MODIFICATIONS TO EXISTING DA

MOD DA 2020/0214 REV A

project **20 PALM BEACH ROAD** PALM BEACH **MODIFICATIONS TO EXISTING DA**

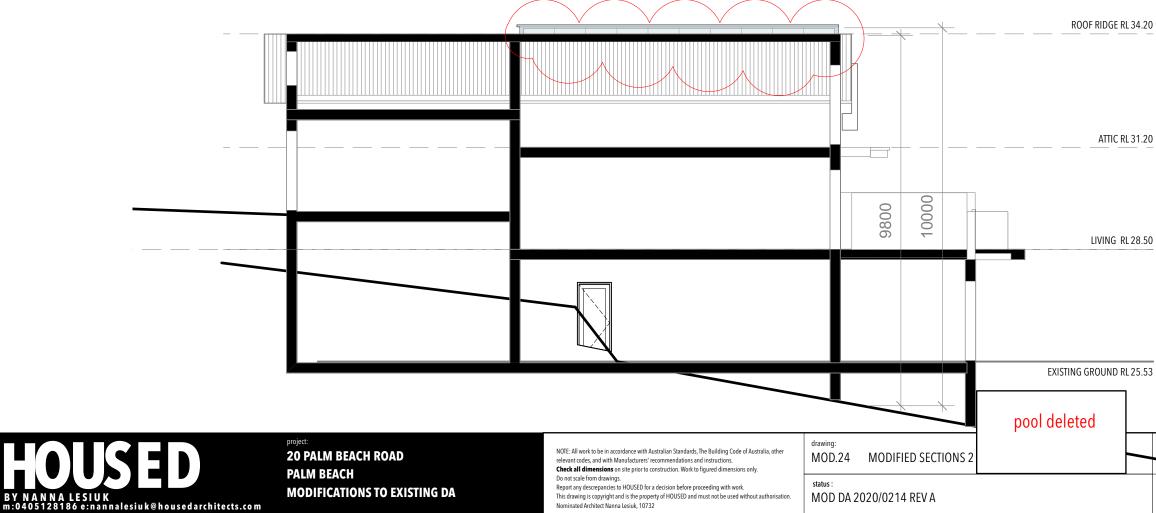
roof revision 6.8.21 - linking skillion lowered +200mm over approved
